<b>Docket Number:</b>	17-BSTD-01
<b>Project Title:</b>	2019 Building Energy Efficiency Standards PreRulemaking
<b>TN #:</b>	220312
<b>Document Title:</b>	Philips Lighting Comments on draft CASE Report NR Indoor Light Sources
<b>Description:</b>	N/A
<b>Filer:</b>	System
<b>Organization:</b>	Philips
<b>Submitter Role:</b>	Public
<b>Submission Date:</b>	7/23/2017 7:30:20 PM
<b>Docketed Date:</b>	7/24/2017

**Philips Lighting Comments on draft CASE Report NR Indoor Light Sources**

**Philips Lighting Comments on the Draft CASE Report (June 2017) Light Sources/LPDs for the 2019 California Building Energy Efficiency Standards, California Code of Regulations, Title 24, Part 6**

Figure 1

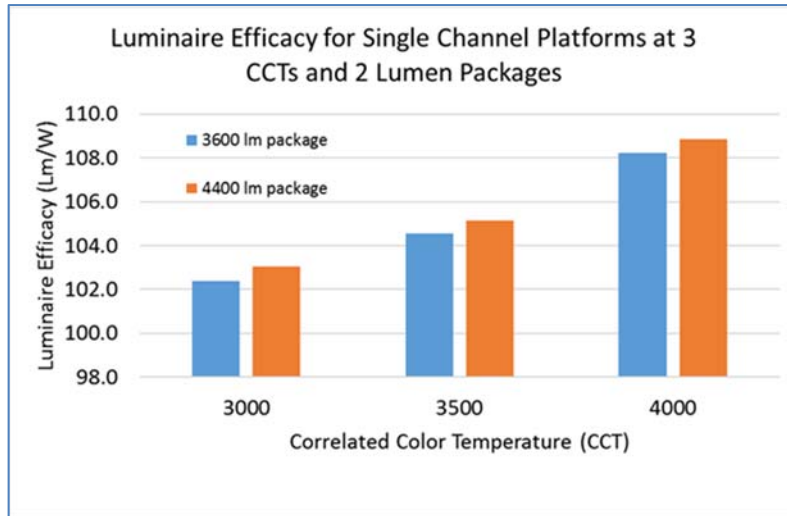
Figure 1 shows luminaire efficacy for a single channel static LED platform at three different CCTs (3000K, 3500K, and 4000K) and two lumen output (3600 lm, 4400 lm) packages. The data in this graph is for one LED board and measured at six discrete points.

Figure 2

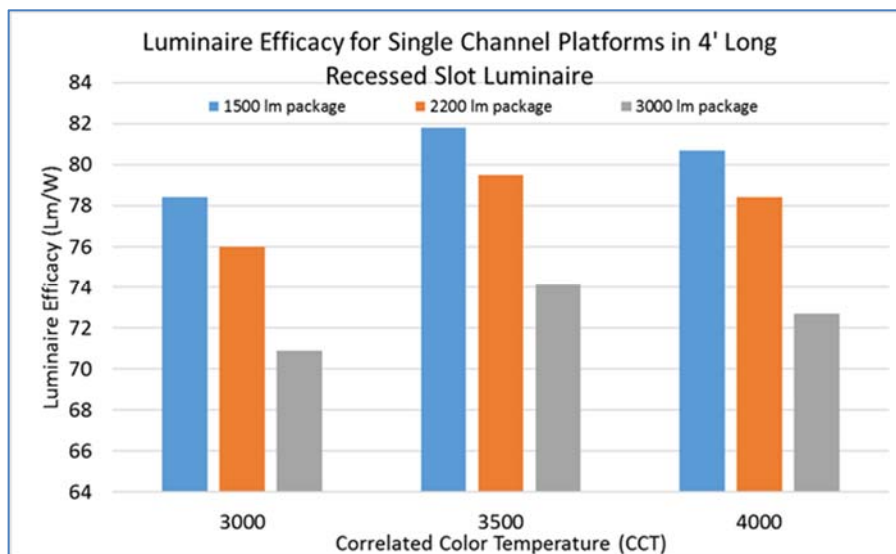
Figure 2 shows luminaire efficacy for a different single channel static LED platform at three CCTs (3000K, 3500K, and 4000K) and three lumen (1500 lm, 2200 lm, 3000 lm) packages. The data in this graph is for one LED board and measured at nine discrete points.

Both of these graphs show efficacy data for static LED (fixed CCT) luminaires, while the third graph shows efficacy for a tunable (variable CCT) luminaire. The relationship between luminaire efficacy and light output is predictive and depending on the design of the system efficacy, either increases or decreases with light output for single channel LED systems.

Figure 3

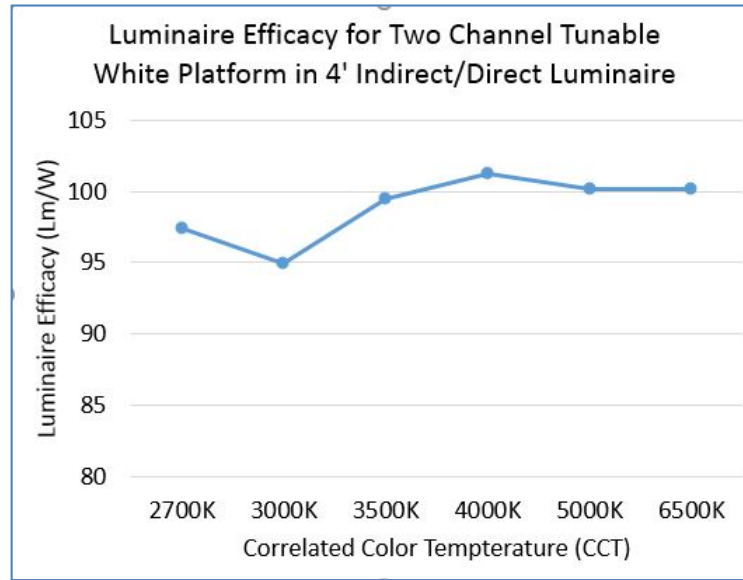
Figure 3 below shows luminaire efficacy for a two channel tunable white LED platform. The measured data and the line connecting the data points show the expected trend for luminaire efficacy for this particular tunable white luminaire when light output is held constant at 5000 lm.

Examining the trend line clearly indicates that the luminaire efficacy does not follow a predictable pattern. From the measured data, we also know that the relationships between efficacy, light output, power, and color are also not constant in a variable CCT system.

As a result, it is not possible to make assumptions about luminaire efficacy for multi-channel LED systems without knowing the details of the electrical circuitry and board design, and the number of channels at a minimum.

Based on this knowledge, we urge the Statewide CASE Team and the CEC to do further research into multichannel LED systems and caution the setting of requirements that may be too stringent or lighting power density values that may be too low to accommodate yet-to-be-released tunable white systems. We agree that variable CCT systems could potentially result in a lower efficacy because efficacy is not intuitive nor predictable in a multi-channel LED system.
